REMARKS

The present response is submitted in response to the Office Action of June 6, 2005. The Applicant respectfully requests that the Examiner enter the requested amendments and following remarks upon reconsideration of this Application.

10/776,564

Fig. 1

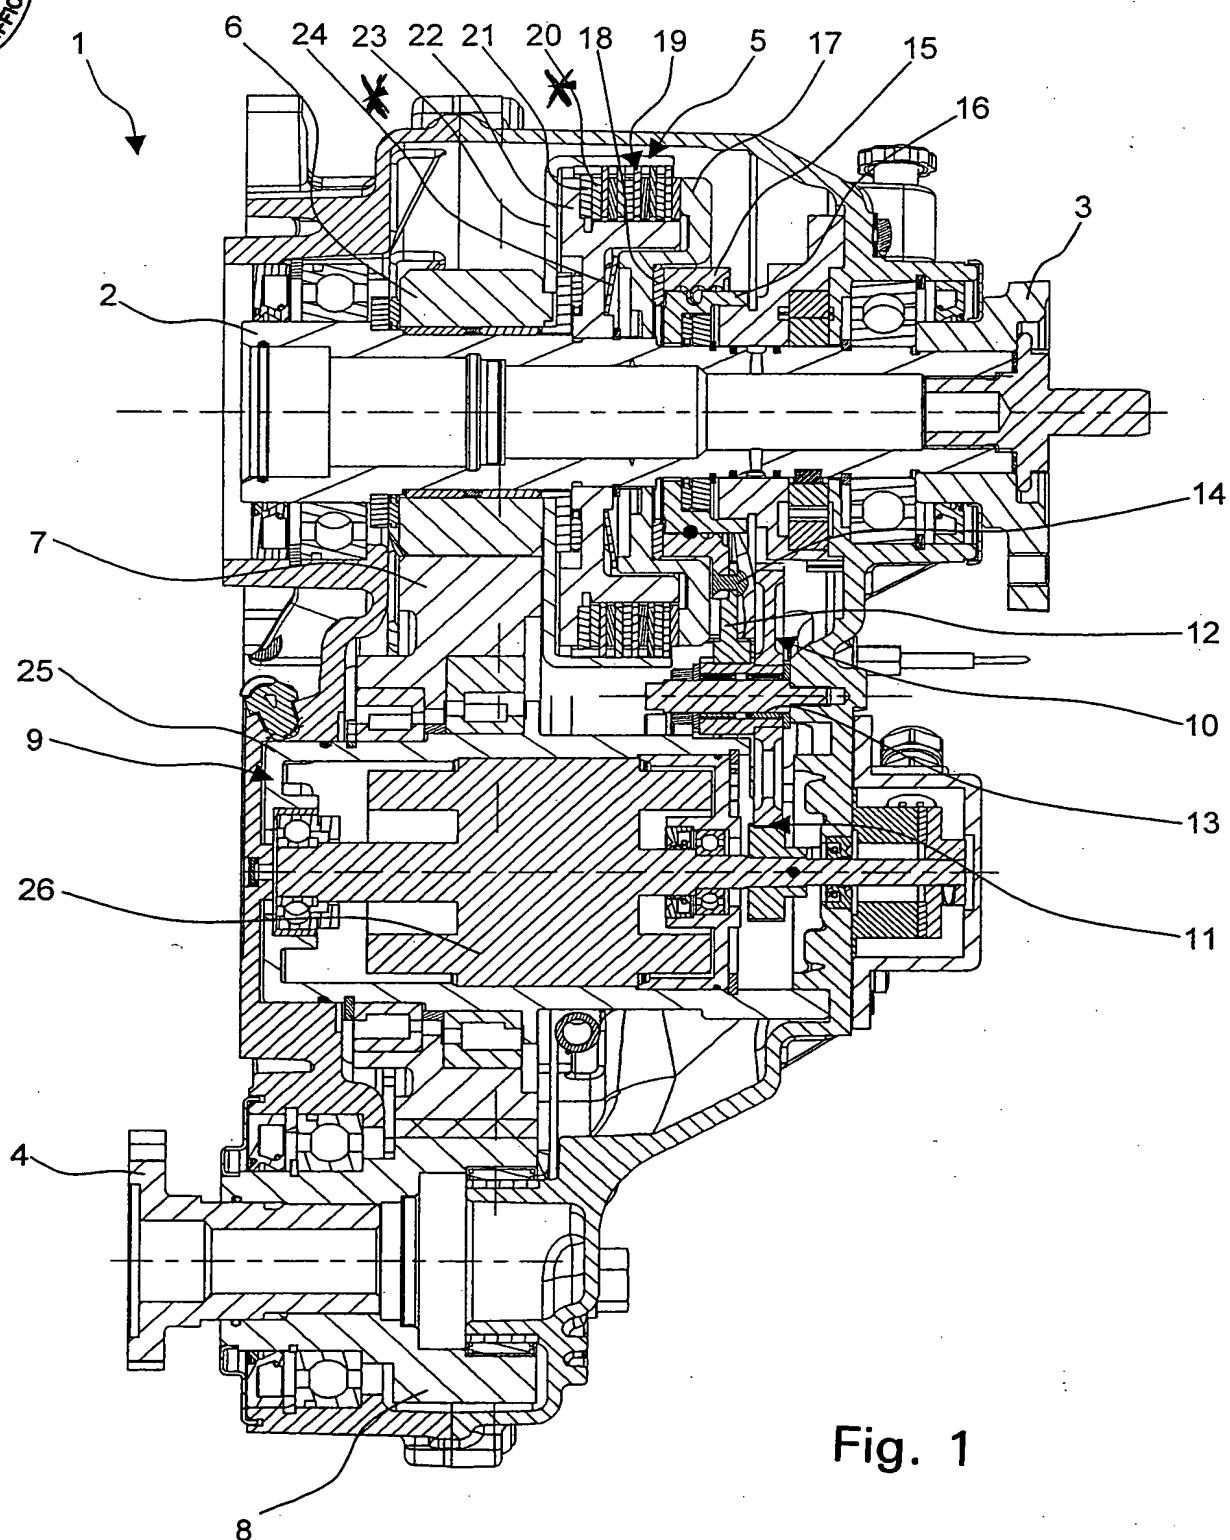
delete ARROWS

Fig. 2

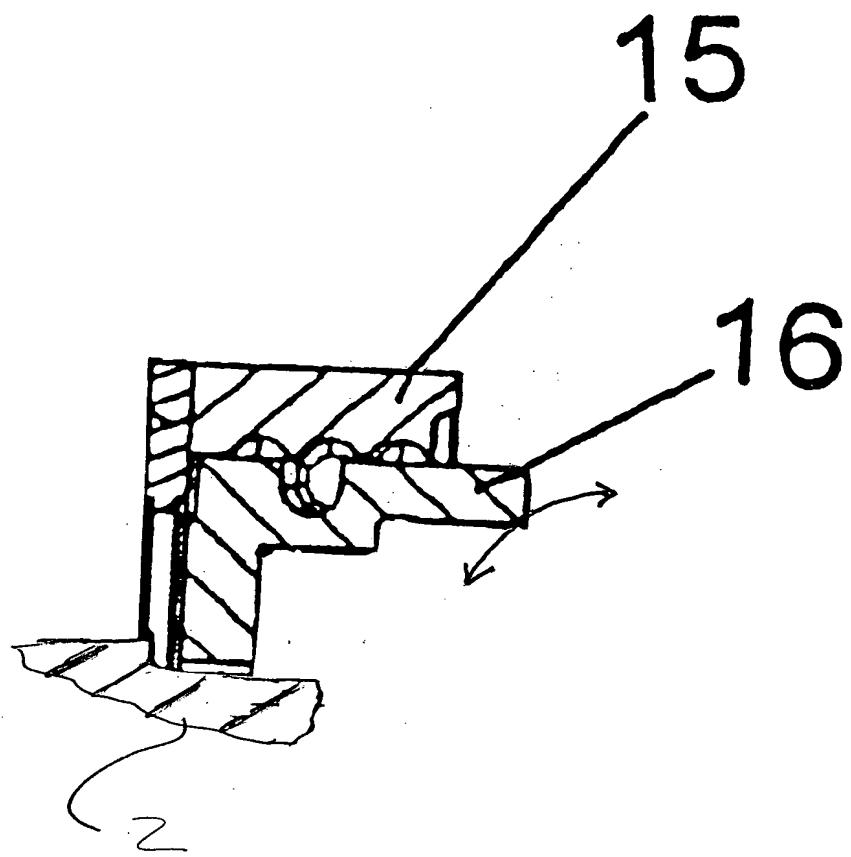
The drawings are amended, per the attached Submission, to overcome a few noted informalities contained therein and show the recited features of claim 12. The new Replacement Sheets of formal drawings, accompany this Submission, incorporate all of the requested drawing amendments. In the Fig. 2, a fixed spindle nut 15 and a spindle 16 which can be rotated relative thereto is now shown. It is respectfully submits that original claim 6, for example, provides support for such this new drawing and thus no new matter is entered by the same. If any further amendment to the drawings is believed necessary, the Examiner is invited to contact the undersigned representative of the Applicant to discuss the same.
